ADDENDUM NUMBER 1:  
Portsmouth City Boiler Plant Improvements Project  
Bid Proposal #37-12

Issued: June 20, 2012

This Addendum forms part of the original document marked: **Plains Park Improvements Bid Proposal #37-12**

Sheet Number:  
**SP-1**  
 Sheet 3 of 14

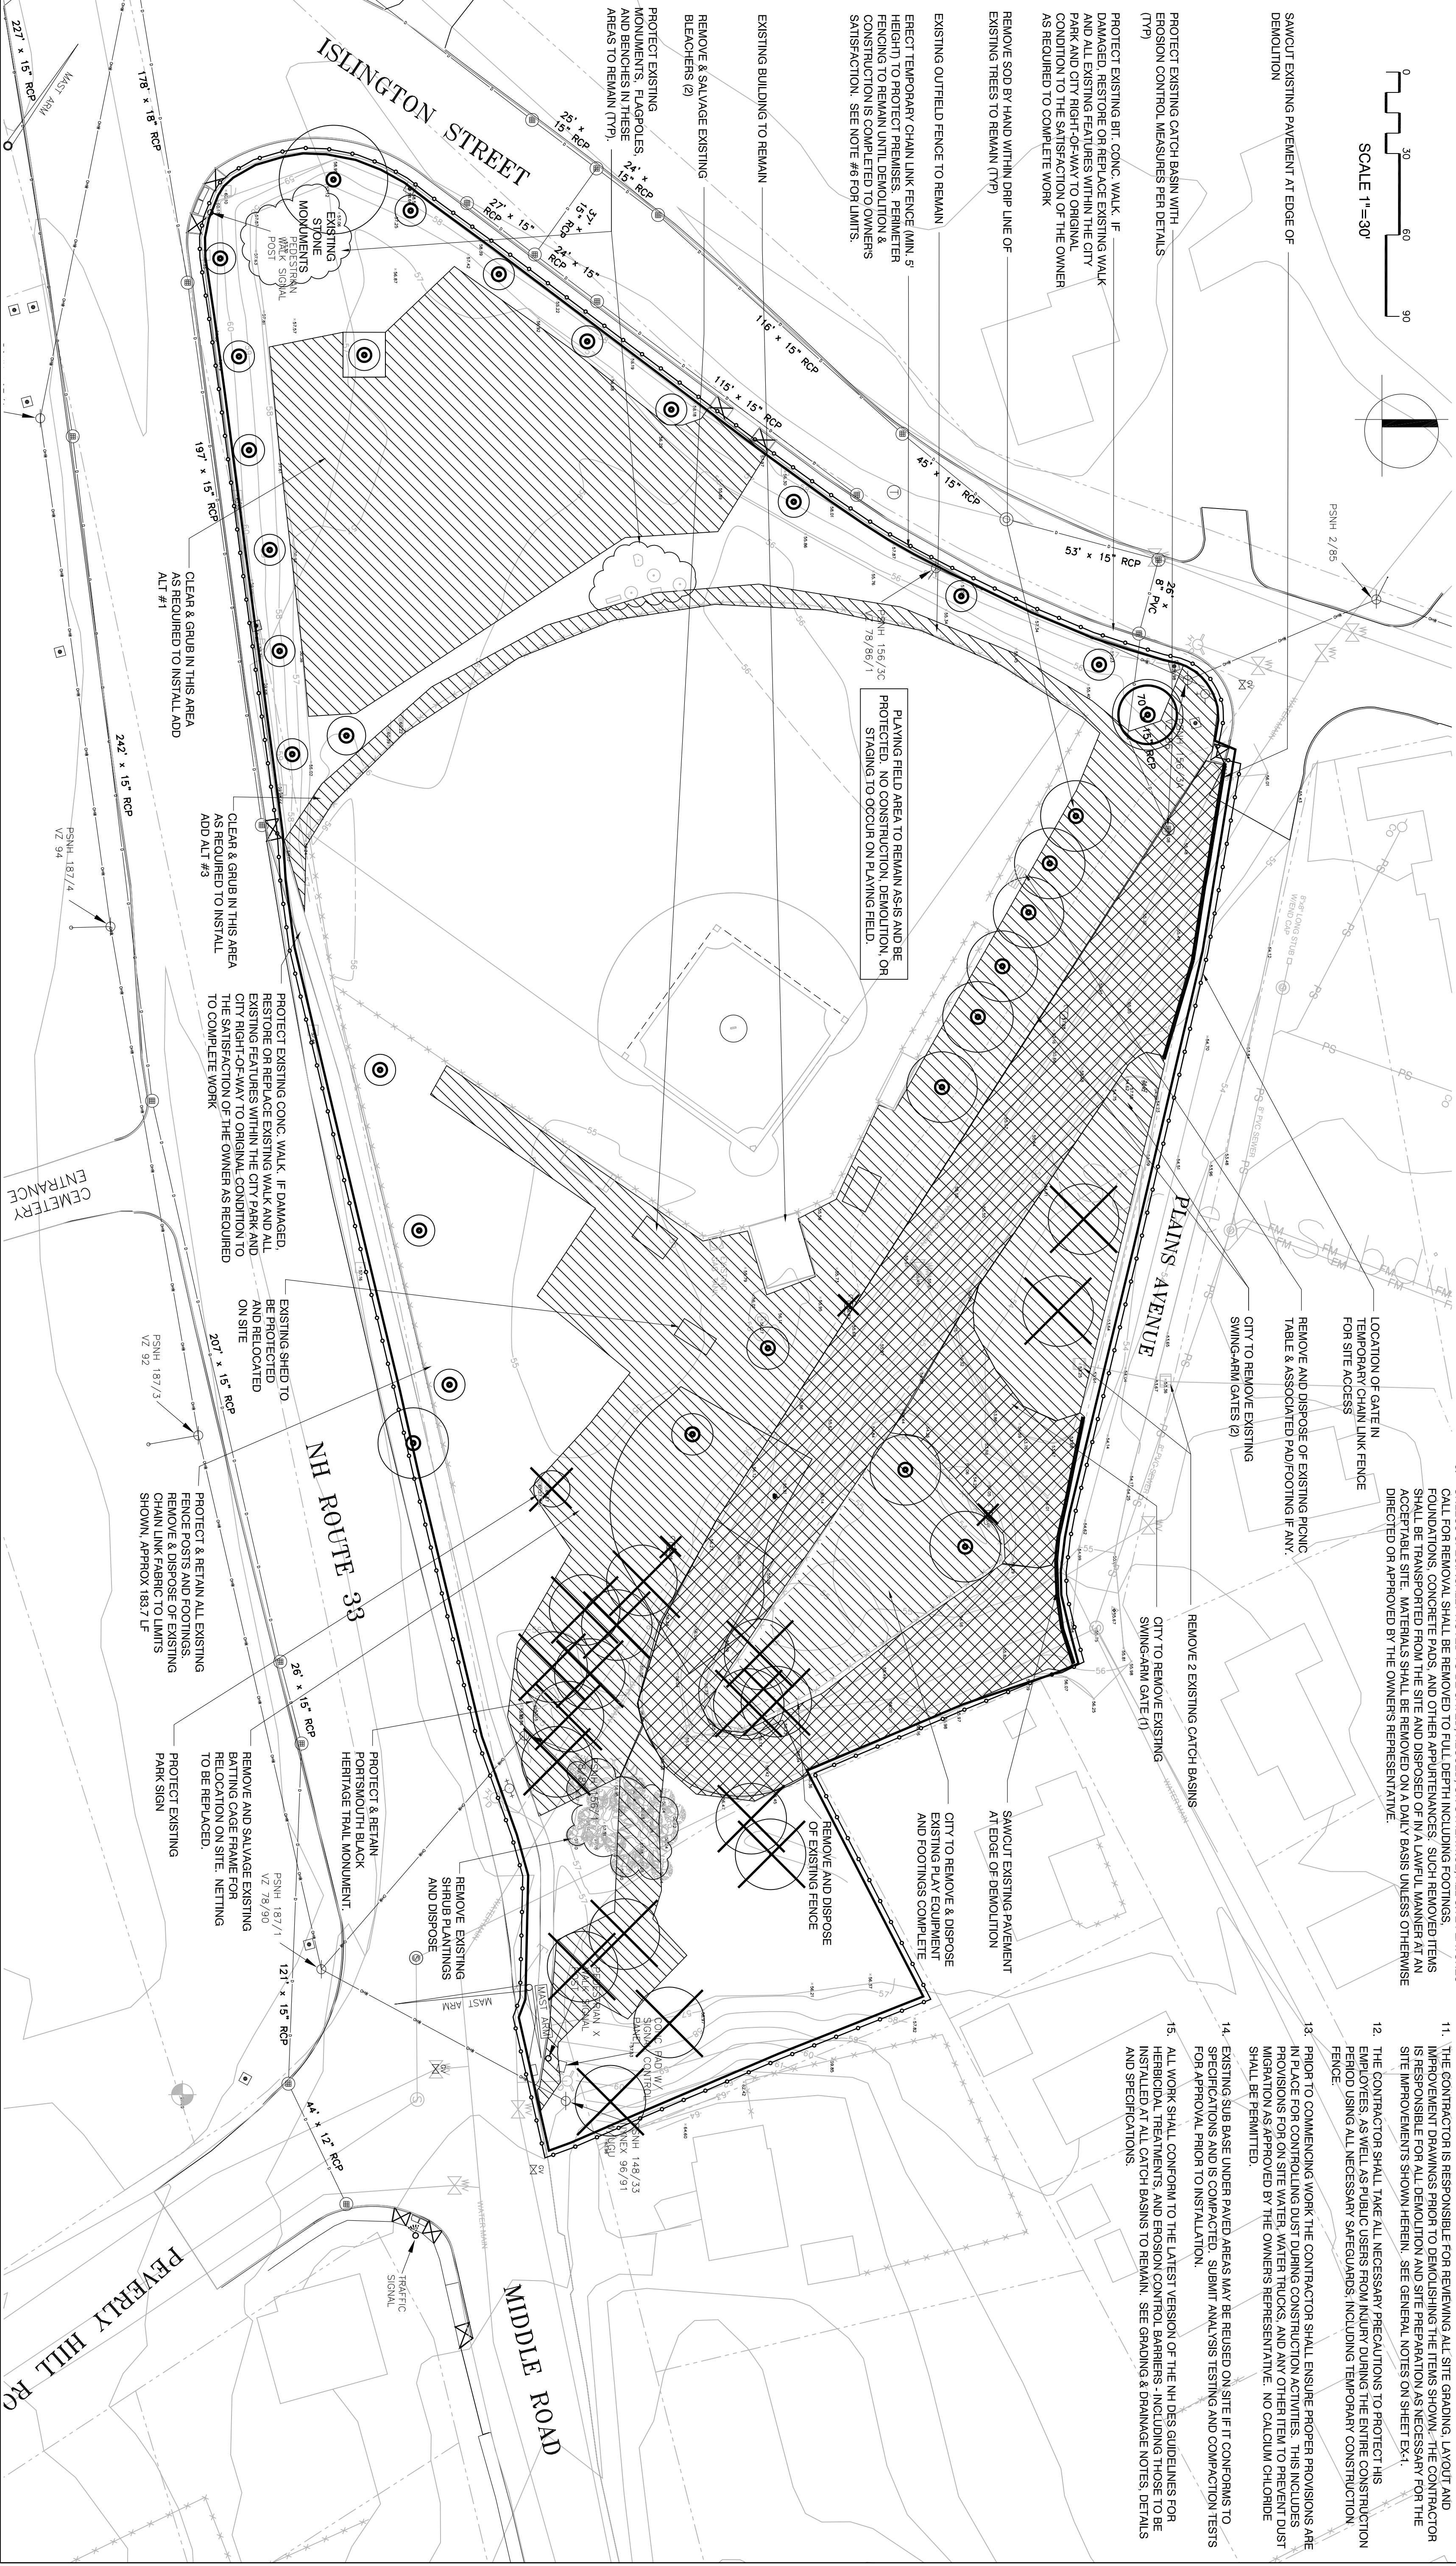
2. The perimeter temporary fencing depicted on SP-1 will not be required as part of this work. The contractor is responsible for a secure staging area on-site to prevent public access and theft of project equipment, materials, etc. The location to be approved by City representative.
